Re: **Initial Submission Review** – Sterling Hills AMH – Site Plan and Plat
Application Number: **DA-1052-24**
Case Number: **2019-4014-00; 2019-3044-00**

Initial Submission Review

LOCAL TYPE II
PRIMARY DRIVE A, PRIMARY DRIVE B.
N.T.S.

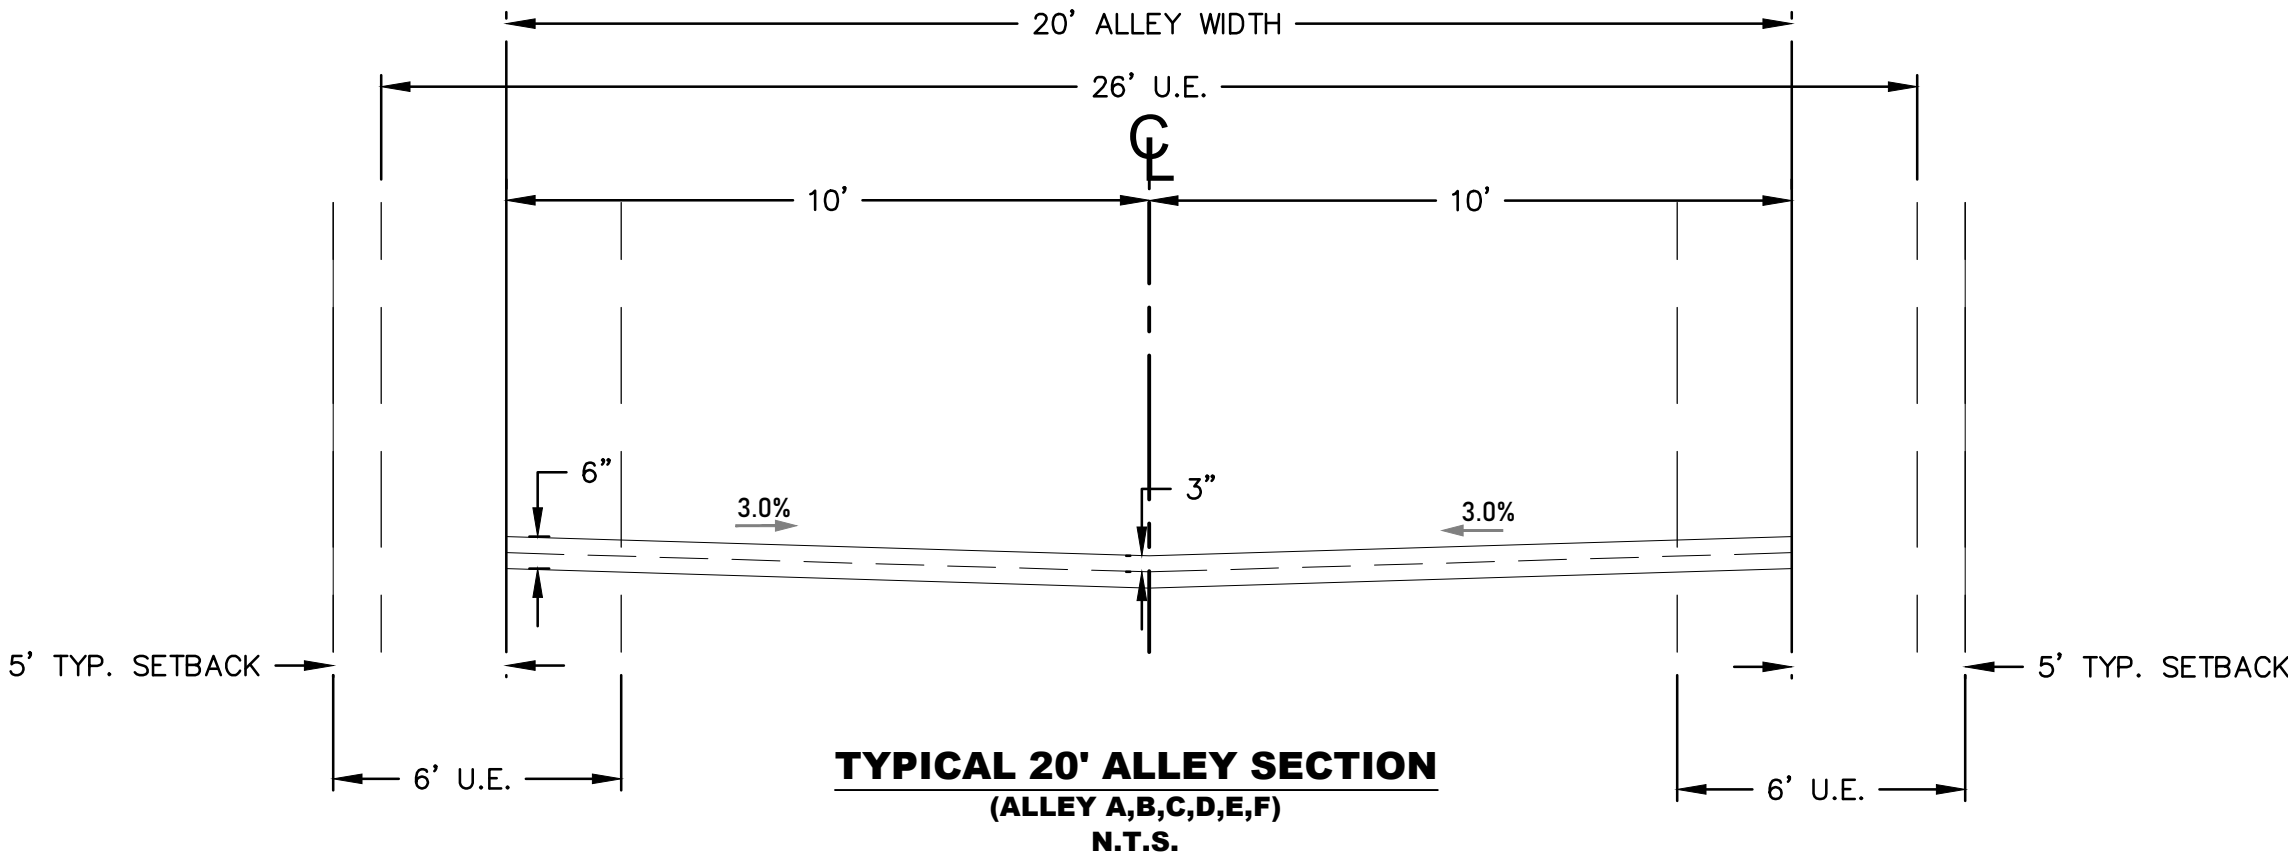
Please add the following note: ATTENTION BUILDING DIVISION: per ARTICLE xi, C.O.A. Building and Zoning Code, Section 22-425 through 22-434, AN ACOUSTIC ANALYSIS, PREPARED BY AN ACOUSTIC EXPERT THAT WILL IDENTIFY BUILDING DESIGN FEATURES NECESSARY TO ACCOMPLISH EXTERIOR NOISE REDUCTION TO ACHIEVE INTERIOR NOISE LEVELS NOT EXCEEDING INFLUENCE AREA (LDN VALUE TO BE DETERMINED FOR EACH PROJECT) UNDER WORSE-CASE NOISE CONDITIONS.

Response: The reference to ROW has been removed.

TYPICAL LOT SIZE AND SETBACKS
N.T.S.

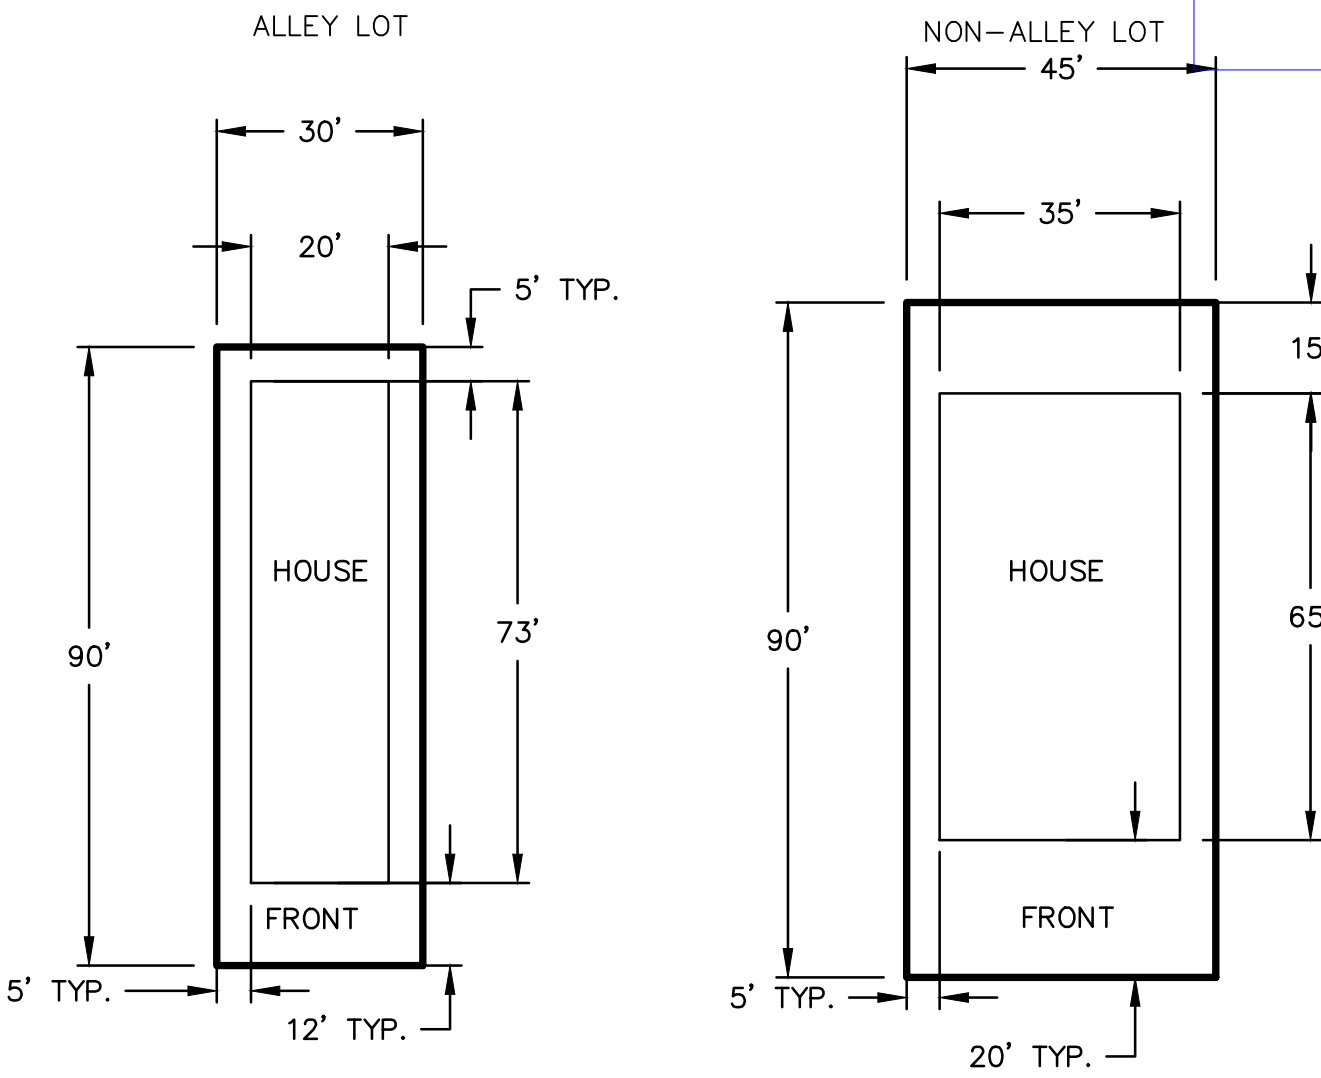
These don't add up to 90. (20+65+15)

Response: The lot dimensions have been updated.

M.U.T.C.D. SIGN DETAILS

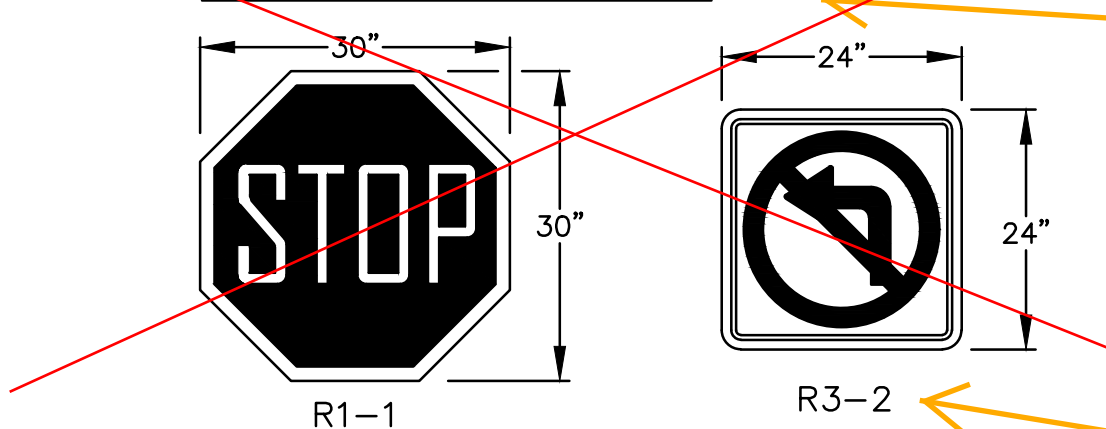
These sign details (including dimensions) need to appear on the Civil Plan (sign & striping) and are not required to be on Site Plan.

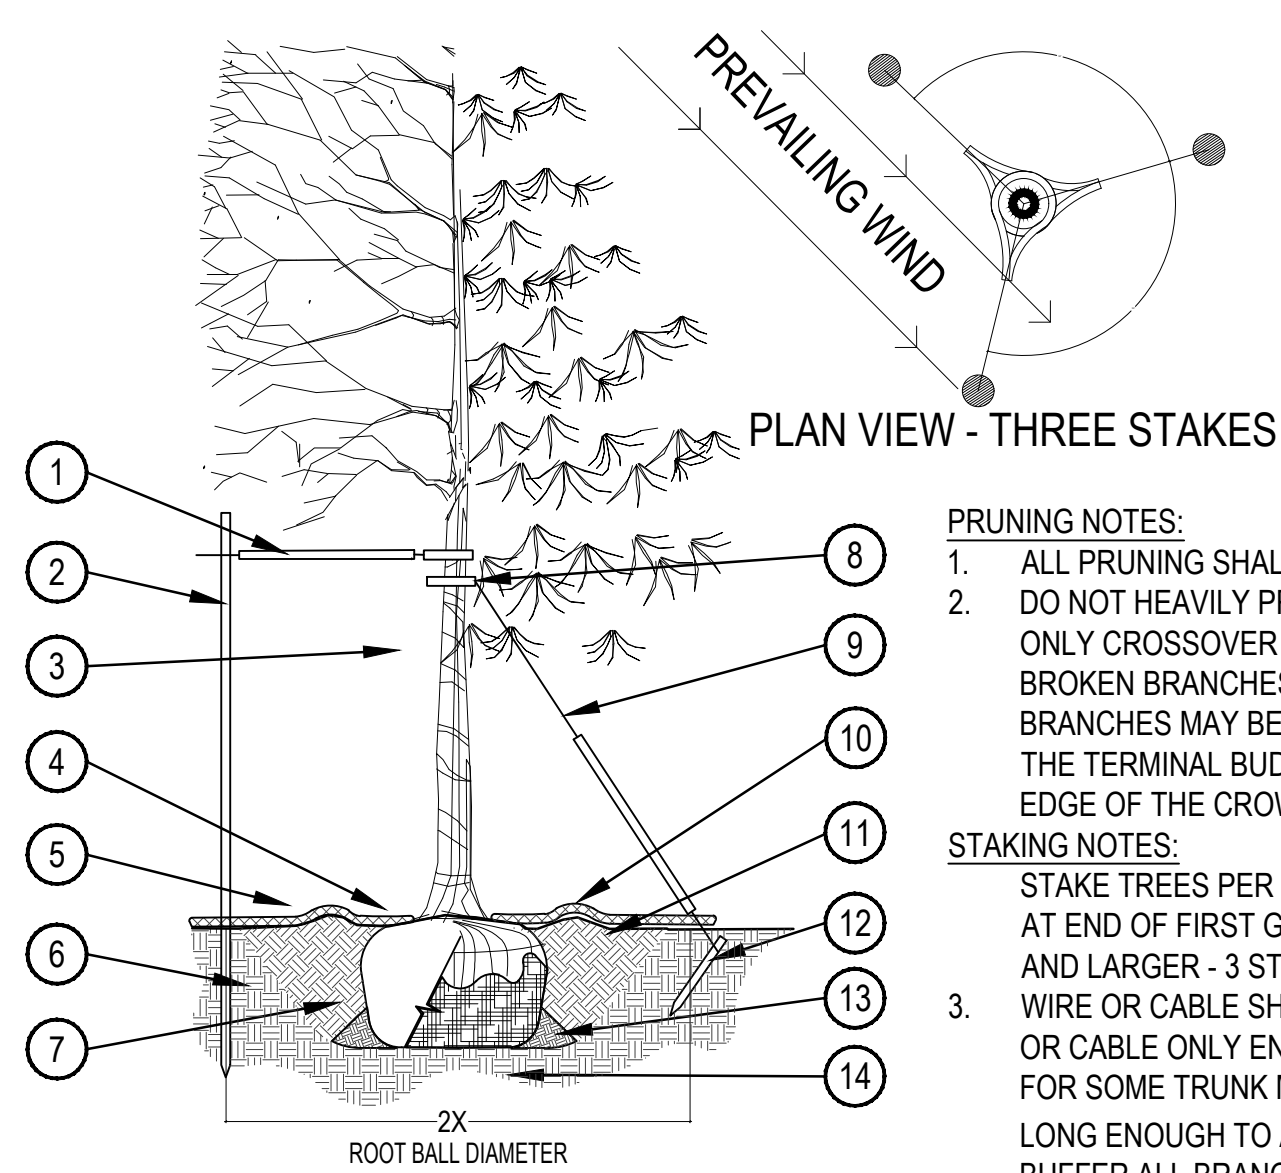
See comment on landscape plan. Previous approved civil plans for E. Water Drive require a "detached" walk.

Response: Table revised so that front yard landscaping is not counted toward open space planting requirements. Street tree table revised to account for street tree requirements independently of open space requirements.

ON-LOT TYPICAL - LOT TYPE B (ALLEY LOT)

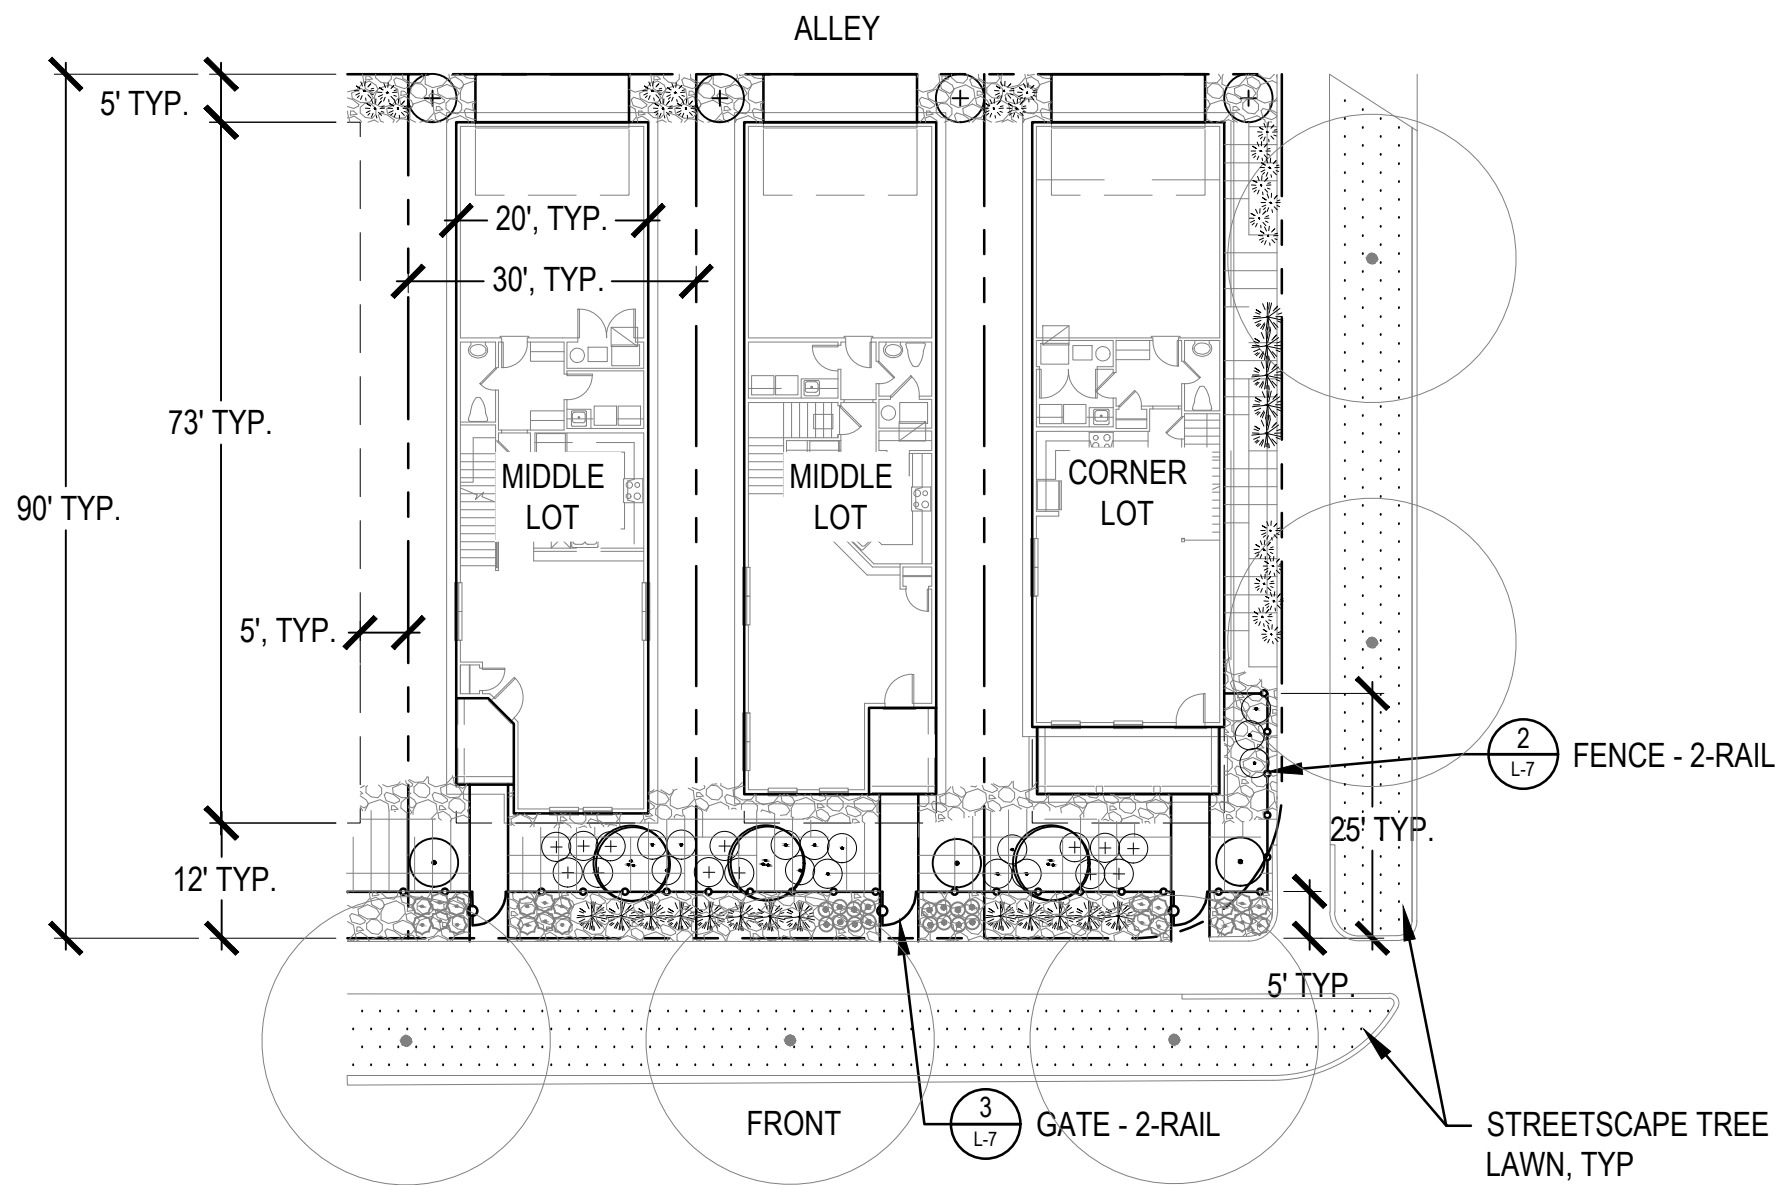
2G. Please provide typical frontage designs for the various circumstances. This should include from the back of curb to the front of house and show tree lawn landscaping, grading, retaining walls, front yard landscaping and anticipated utility easements. With the smaller front setbacks additional coordination of details is required to assure all required landscaping, utilities and urban design elements can be provided in a sustainable and high-quality manner. This would appear to include at least three typical sections for the lots with retaining walls, non-retaining wall and the front-loaded frontages. In particular if we must go with an attached sidewalk along Water then we want to know how that will look and function.
Response: Four lot-typicals will be provided to express the various site conditions and limitations.

PICAL - LOT TYPE A (NON-ALLEY LOT)

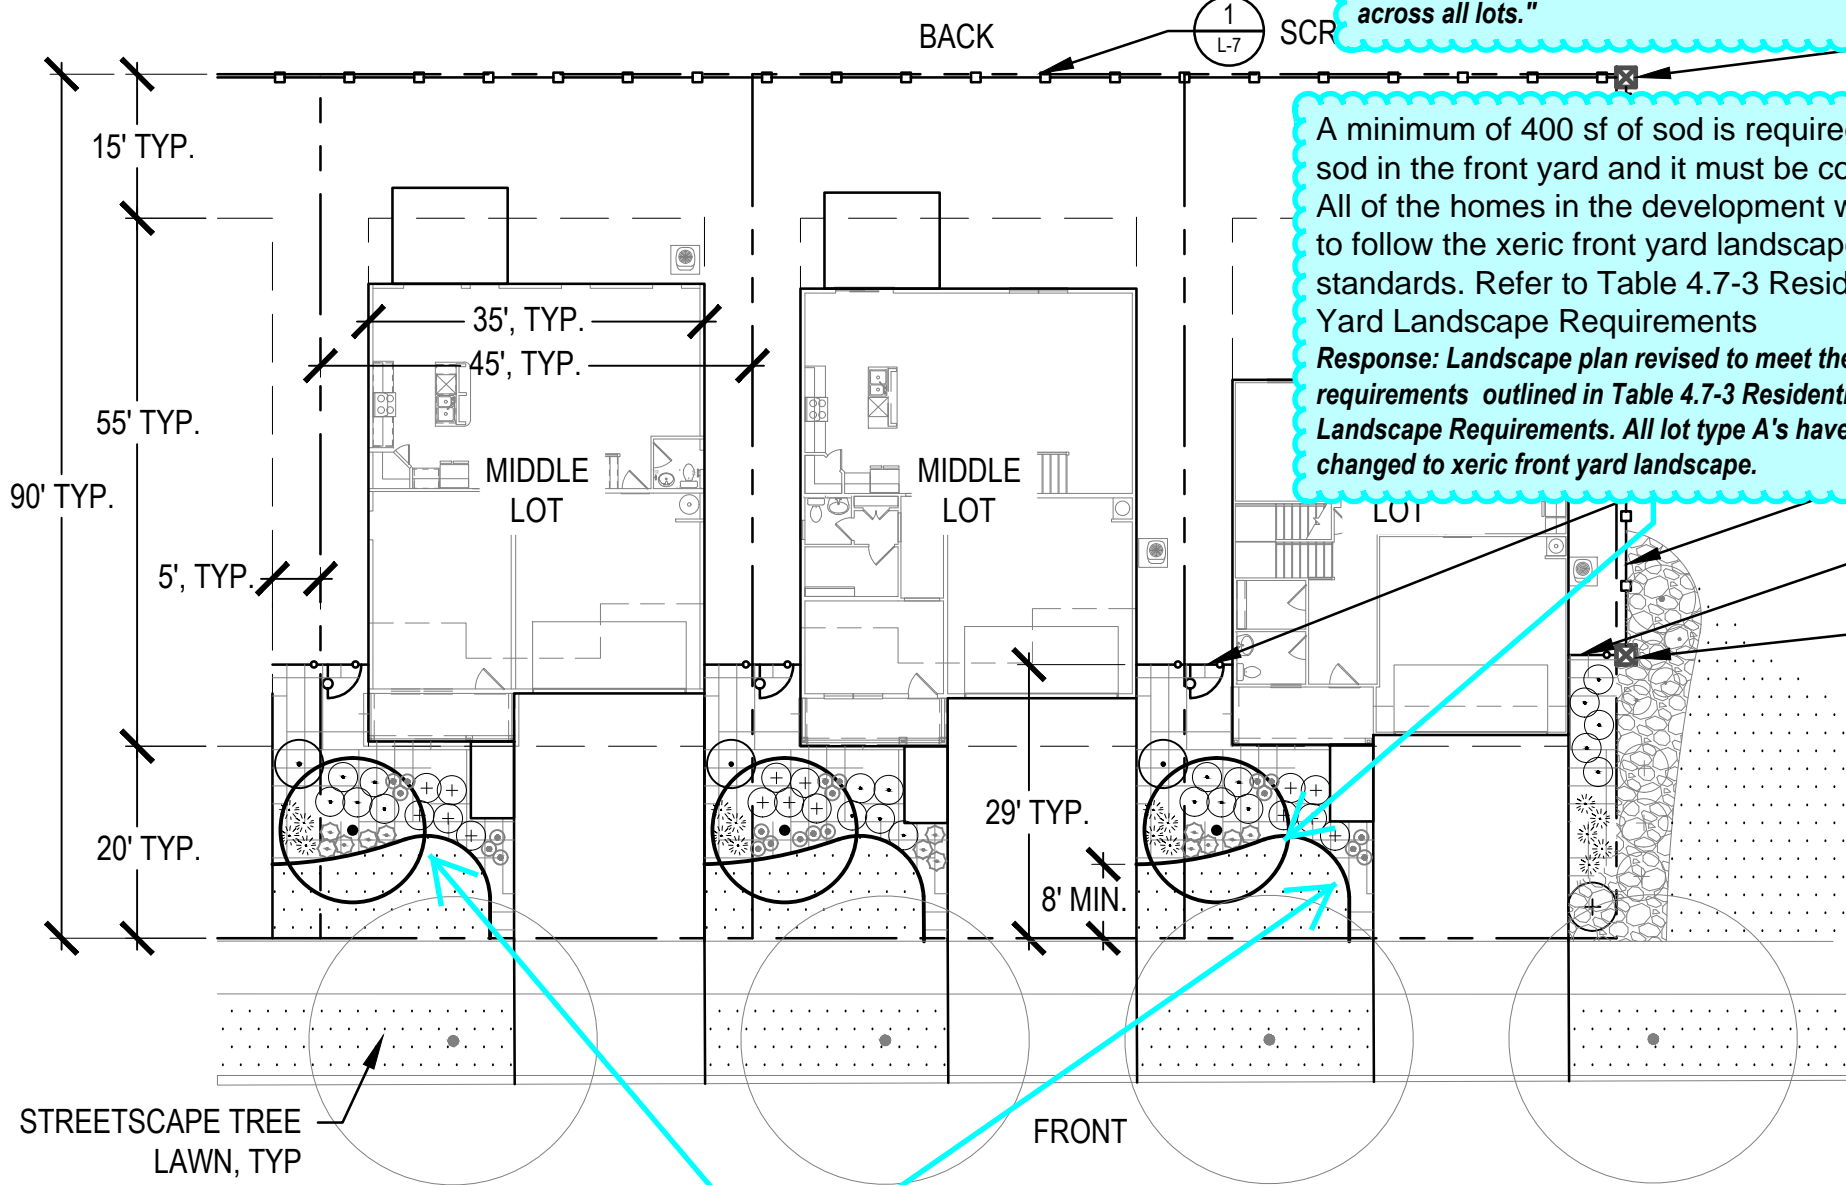
A minimum of 400 sf of sod is required to have sod in the front yard and it must be contiguous. All of the homes in the development will need to follow the xeric front yard landscape standards. Refer to Table 4.7-3 Residential Yard Landscape Requirements
Response: Landscape plan revised to meet the city requirements outlined in Table 4.7-3 Residential Yard Landscape Requirements. All lot type A's have been changed to xeric front yard landscape.

The landscape design should vary. A note should be provided here that describes that as well. Otherwise, it appears from this that they all have the same setback, very similar if not the same architectural fronts and now identical landscaped front yards.
Response: Variation between lots is expressed through a variation in plant material and plant material placement. Sod has been removed to meet the city requirements outlined in Table 4.7-3 Residential Yard Landscape Requirements.

4 FENCE - GUARDRAIL/SAFETY

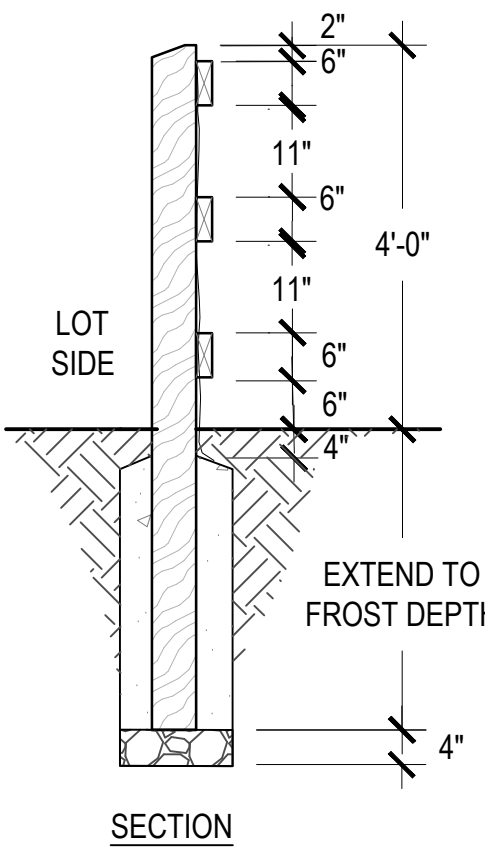
Provide a detail of the proposed wall and the guardrail/safety fence that is proposed for on top of the wall along E. Villanova Place.
Response: Detail 4 represents the proposed guardrail/safety fence that is intended to be located above retaining walls over 30" height. Please refer to the site plan, sheet 4, for additional grading and retaining wall detail, in reference to the proposed guardrail/safety fence.

provide retaining wall details
Response: Retaining wall details will be provided on sheet 4, per civil engineer.
